Advice Letter 6663-E-A, 6663-E-B

SUBJECT: Advice Letter Modifying Electric Rule 21 Pursuant to Resolution E-5172

Subject: Supplemental: Advice Letter Modifying Electric Rule 21 Pursuant to Resolution E-5172

**ELECTRIC RULE NO. 21
GENERATING FACILITY INTERCONNECTIONS**

Flow Chart Sheet 146

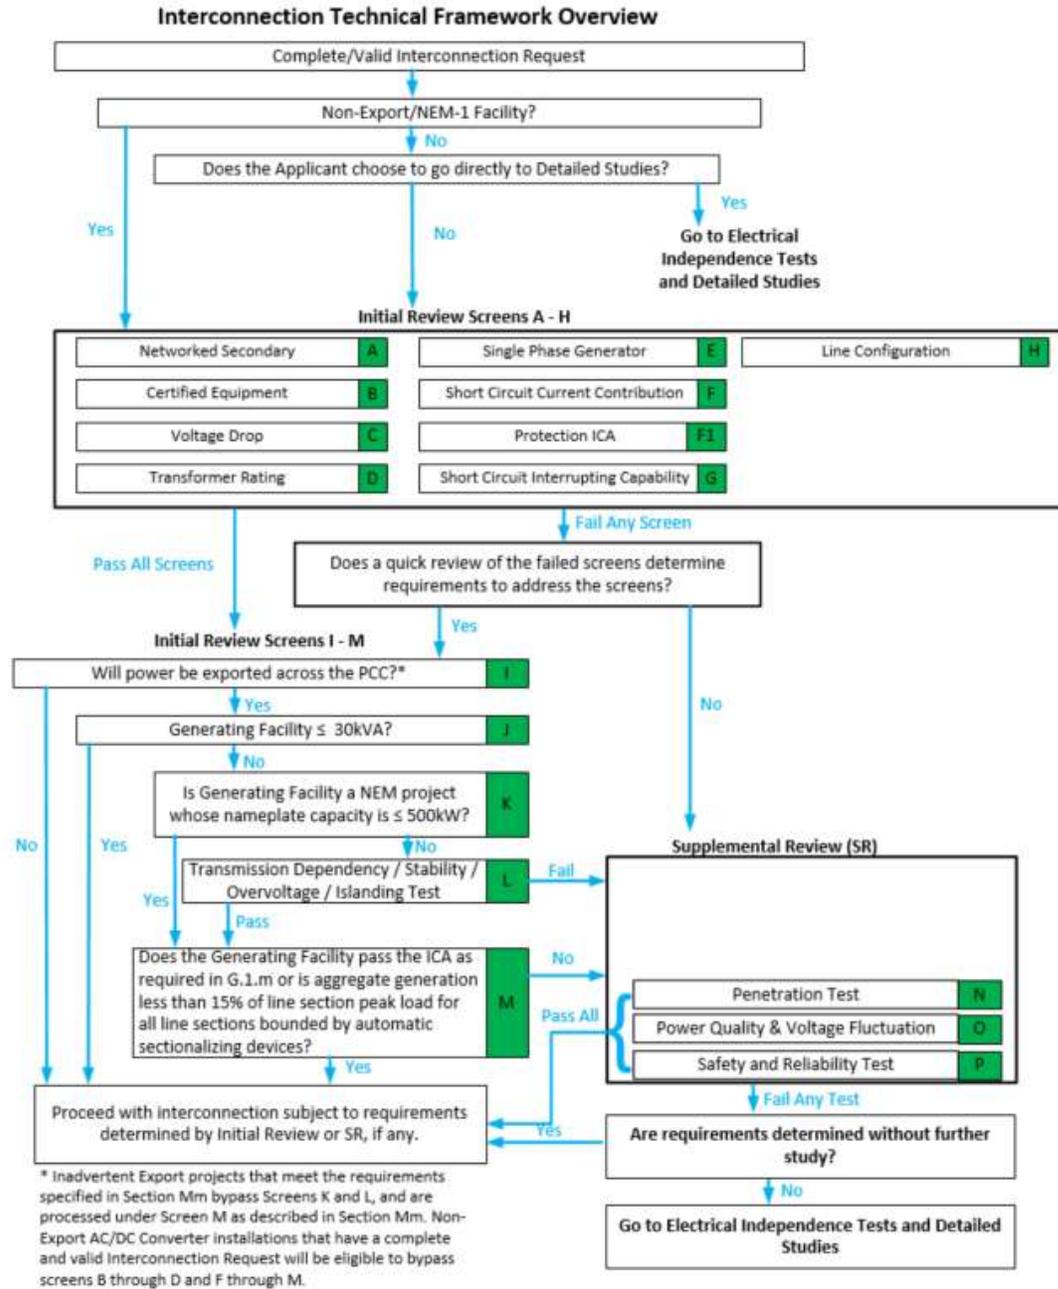
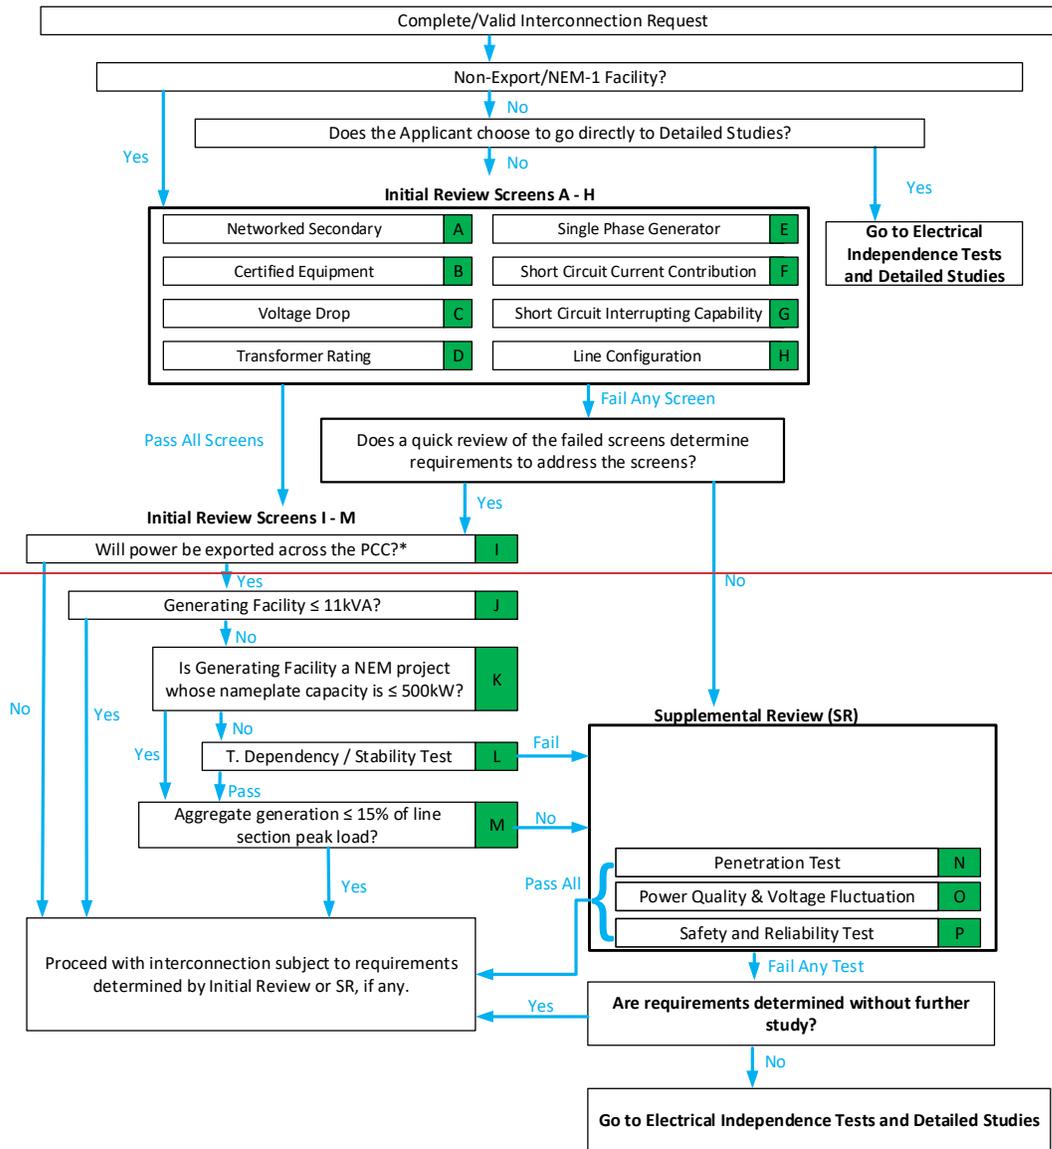
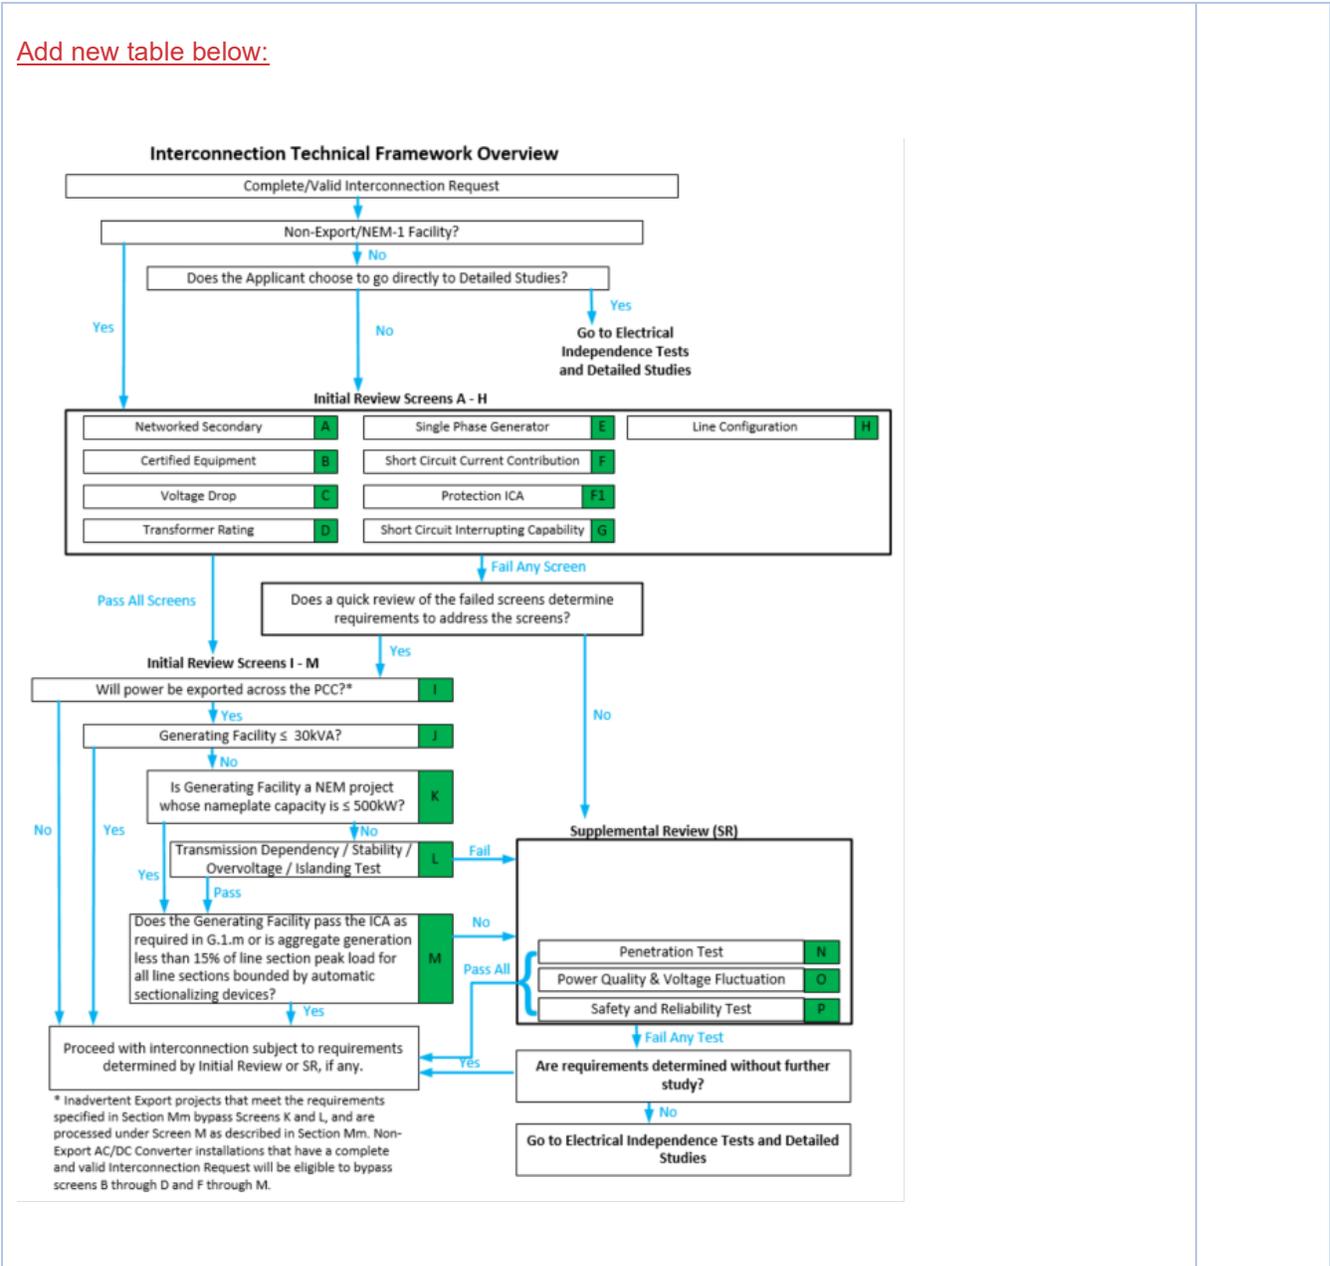
- In Screen J, change “11 kVA” to “30 kVA”;
- In Screen L, delete the letter “T”;
- In Screen M, add the language “for all line sections bounded by automatic sectionalizing devices?”;
